11E

APRIL, 1987
ENGLISH EDITION

1986-1987
GRAND WAGONEER/
TRUCK

INTERMITTENT WINDSHIELD WIPERS

103698

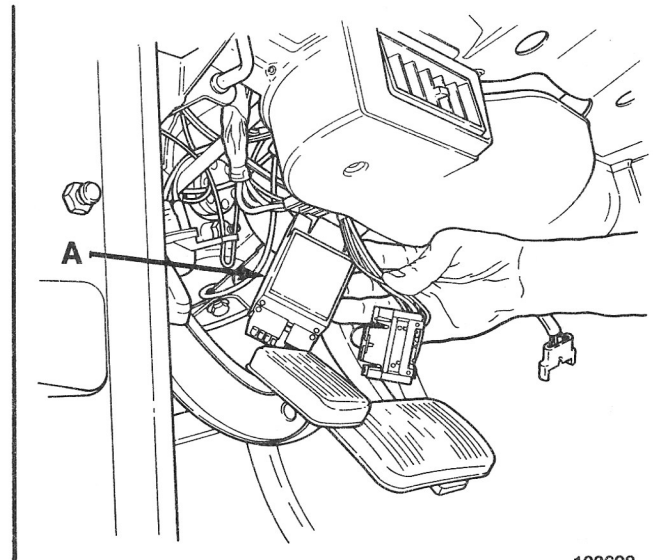
Some 1986 and 1987 Grand Wagoneer/Truck vehicles built before VIN 1JXXXXXXXHTO87763 may have inconsistent intermittent wiper operation.

During high alternator output, such as after starting a cold engine, the intermittent operation of the windshield wipers may become erratic. The timed wiper sweep interval may gradually decrease until there is no pause between sweeps.

Service correction involves replacing the intermittent wiper governor.

1. Locate the intermittent wiper governor (A) under the left side of the instrument panel. Disconnect the connectors on each end of the governor and remove it.
2. Install the two connectors on a new intermittent wiper governor, PN 8956 002 692.
3. Install the new governor under the left side of the instrument panel.
